Subject: Division Street Apartments Structural Checksheet Response
4725 SE Division Street

## Continuous Rod System Submittal

Project Name: **Division Apartments**
Project Address: 4725 SE Division Street
Portland, OR

**Submittal** 06 10 00-1
Holdown Shop Drawings
(Revised Response)

Project
Sheet Title
Scale NOT TO SCALE
File Name TYPICAL
Project No.
Issue Date 8/26/13
Designed
Drawn
Checked
Sheet No. Z4-01

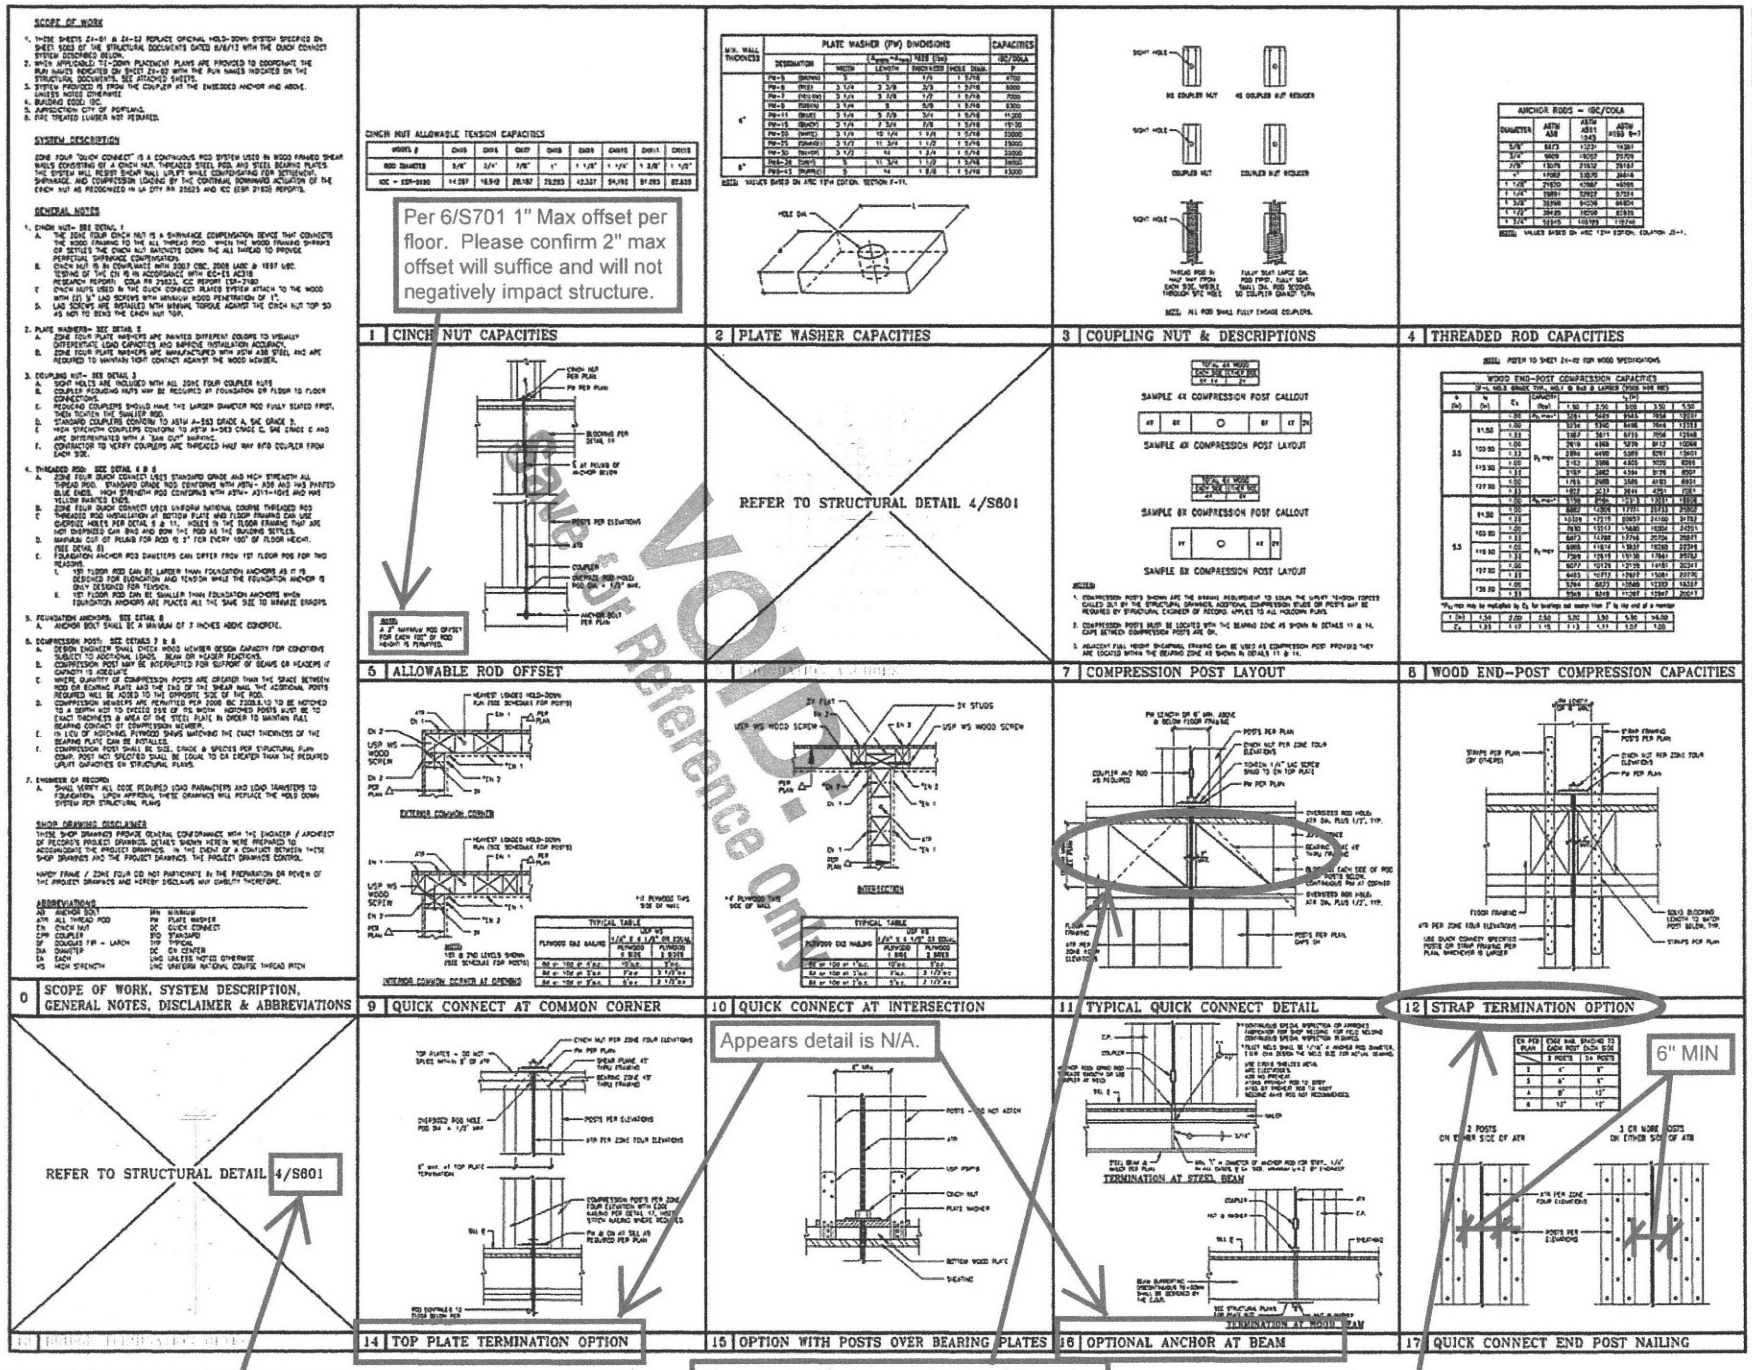
General Note: Cut applicable details on Sheet Z4-01 on Sheet Z4-02 run elevations.

It is not clear if detail 15 is applicable. Contractor to verify and cut all applicable details on run elevations Sheet Z4-02.

Per 6/S701 1" Max offset per floor. Please confirm 2" max offset will suffice and will not negatively impact structure.

Appears detail is N/A.

It appears this is not the correct detail reference. Please provide a detail for mid-wall height run termination (@ run termination header) and cut the detail on the run elevations.

Please note blocking each side of the rod below the floor sheathing is not possible as modified balloon framing is utilized. Please revise as necessary.

Appears detail 12 is not applicable. Contractor to confirm and remove or cross out all non applicable details.

Project
Sheet title
Scale NOT TO SCALE
File name TYPICAL
Project No.
Issue Date 8/26/13
Designed
Drawn
Checked
Sheet No. Z4-02
Sheet of Sheets

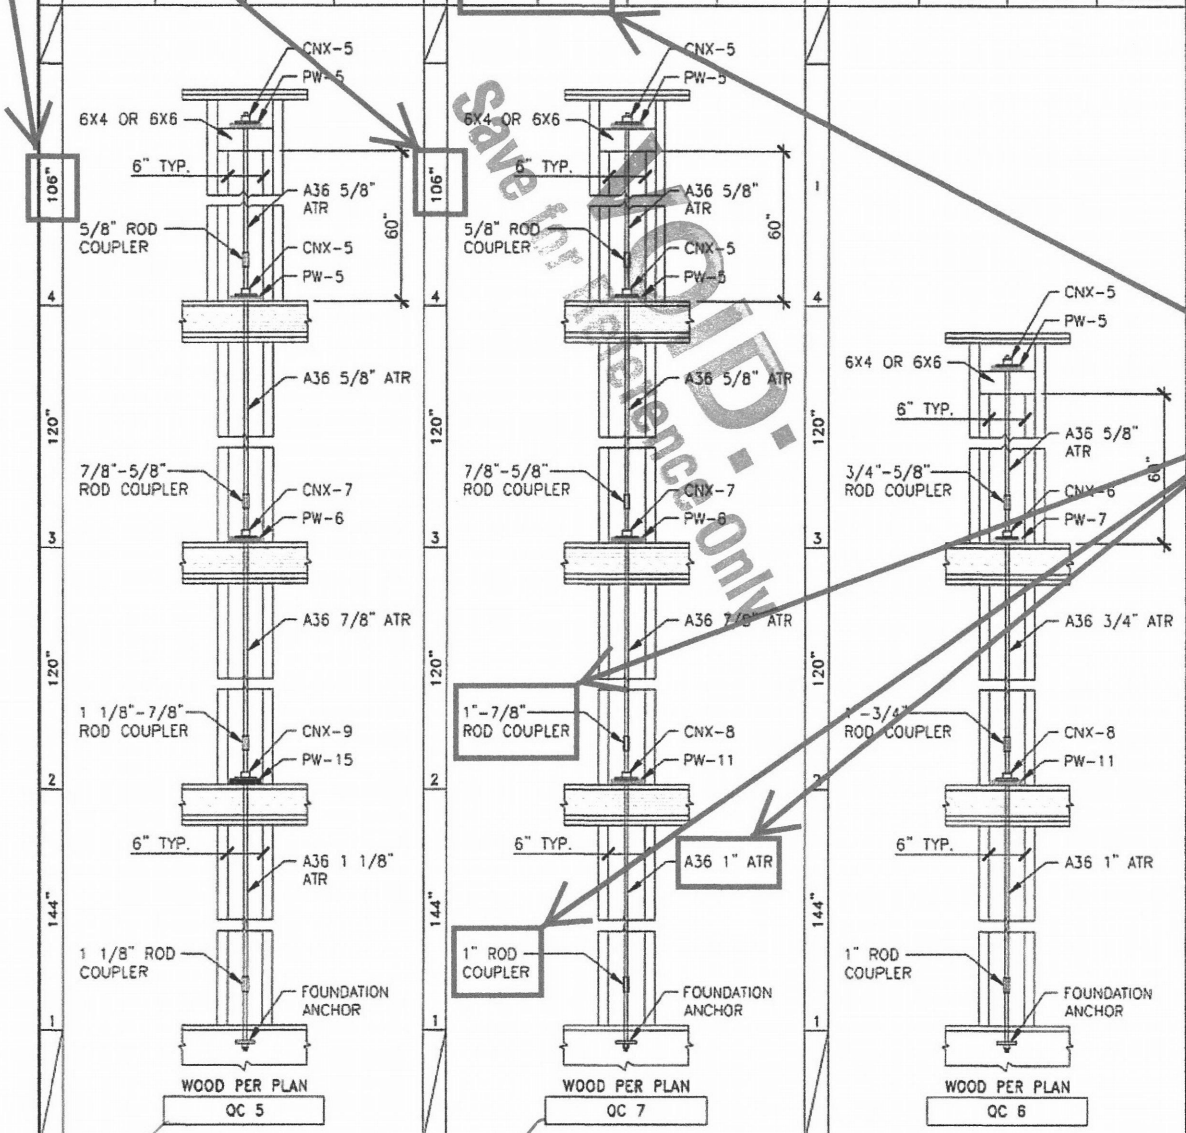
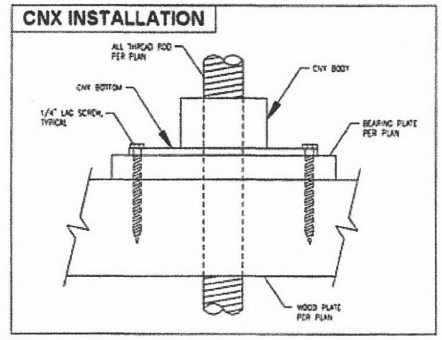
Contractor to verify.

Contractor to verify quantities for each run.

Cut all applicable details from Sheet Z4-01 on Run Elevations 5, 6 & 7.

VOID: Save for Reference Only

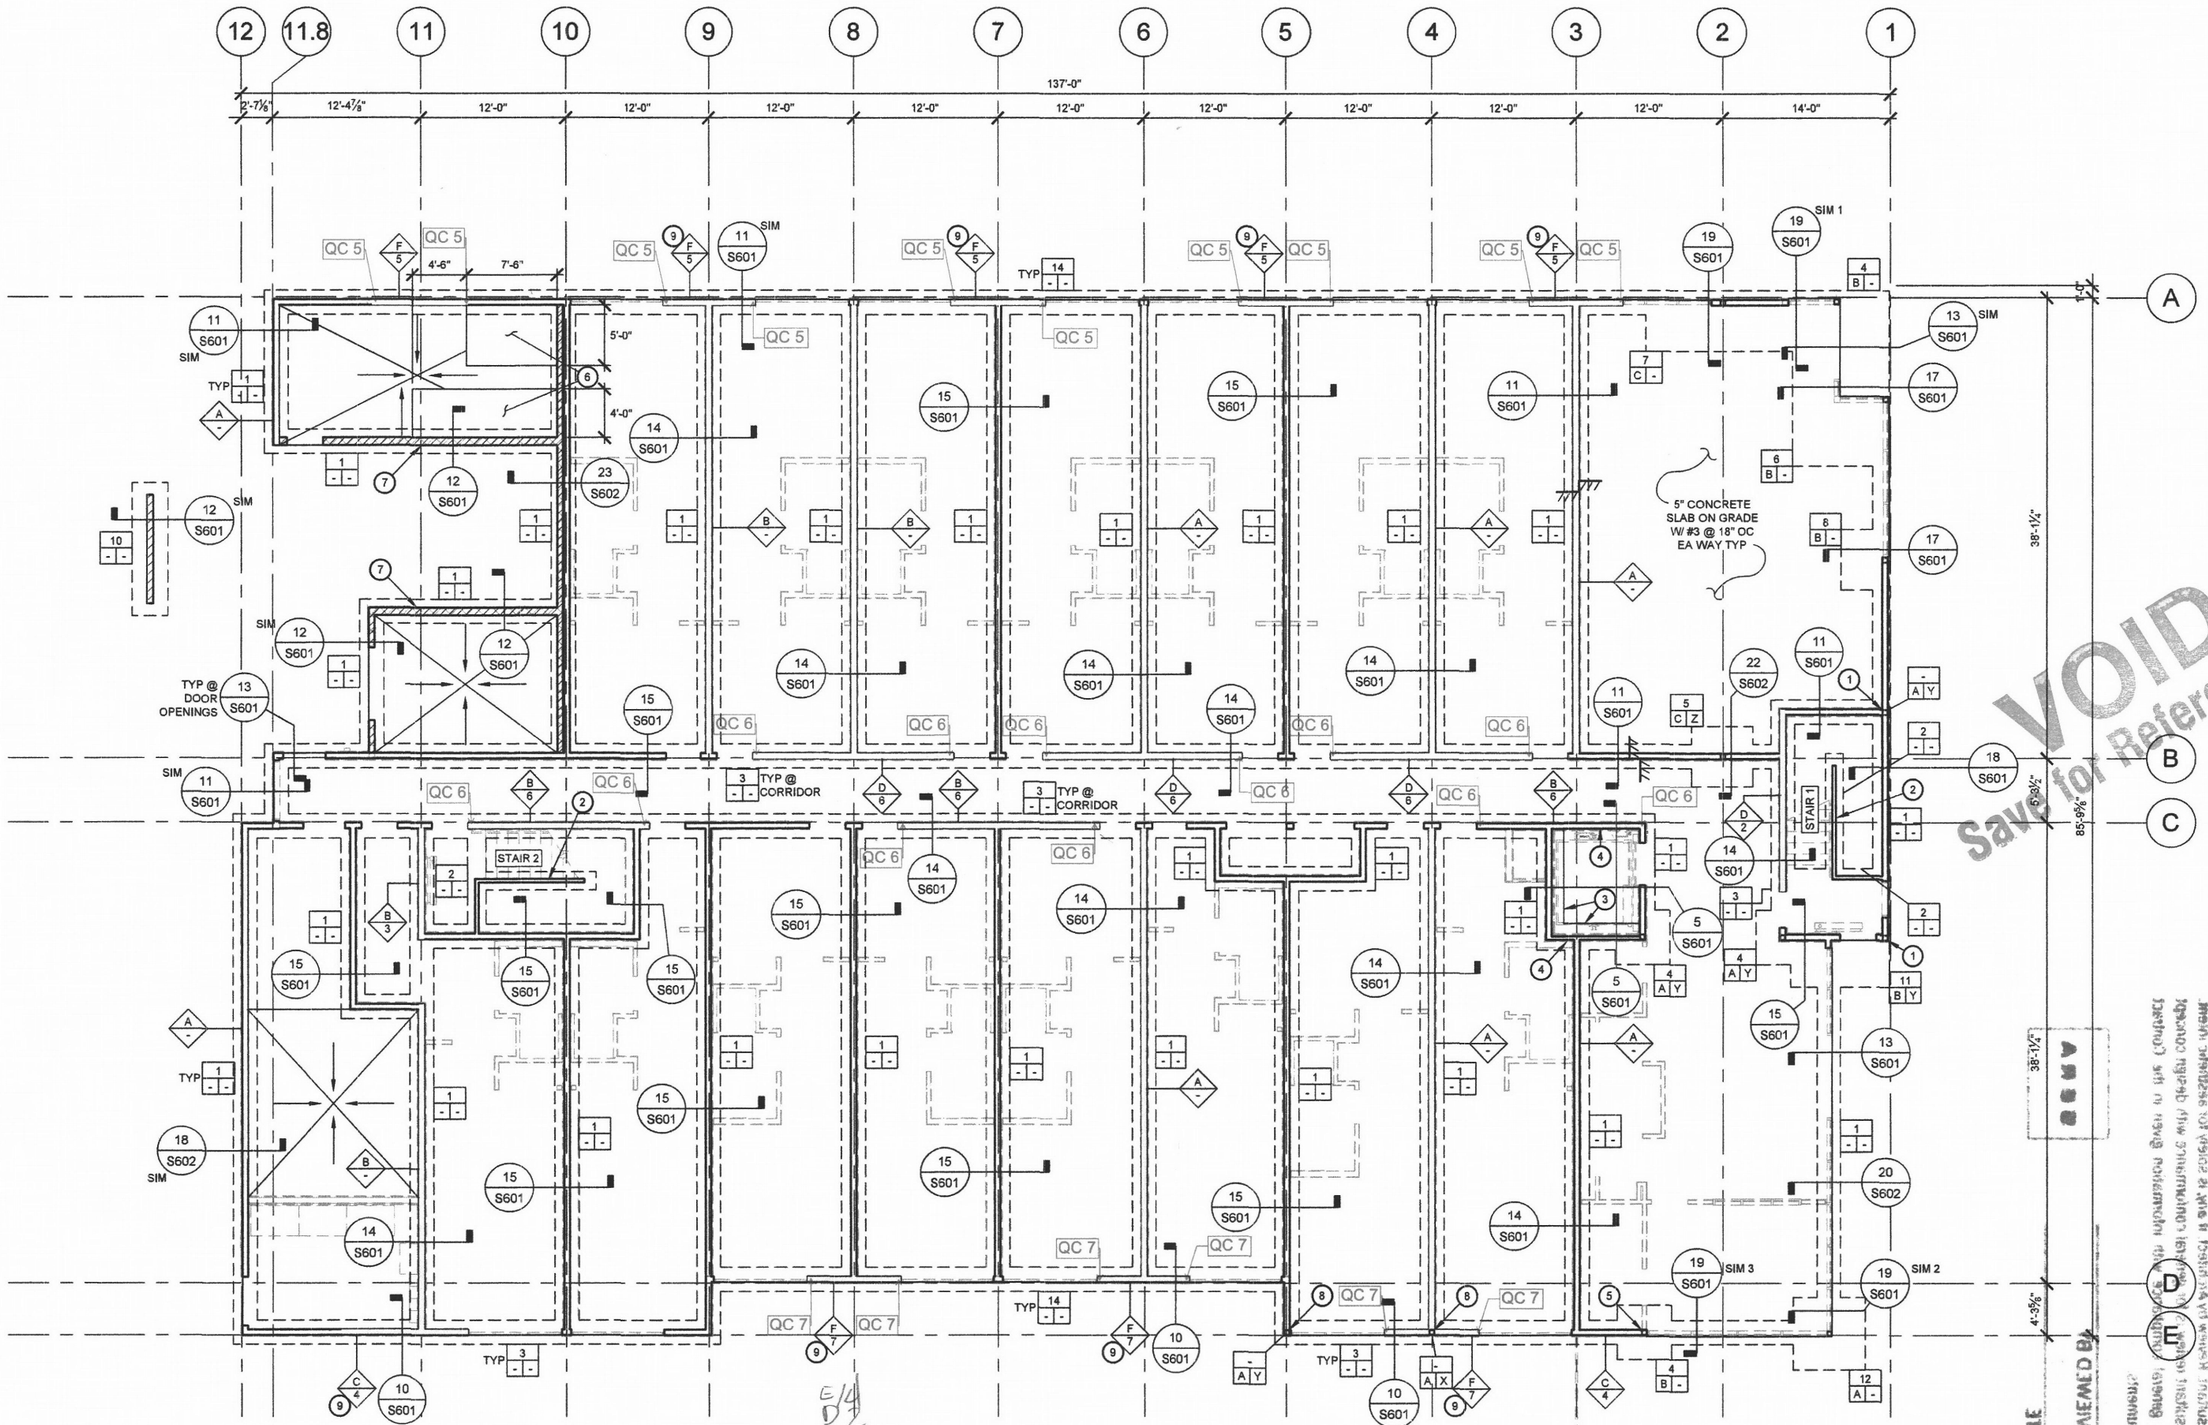
3 stories
not 4
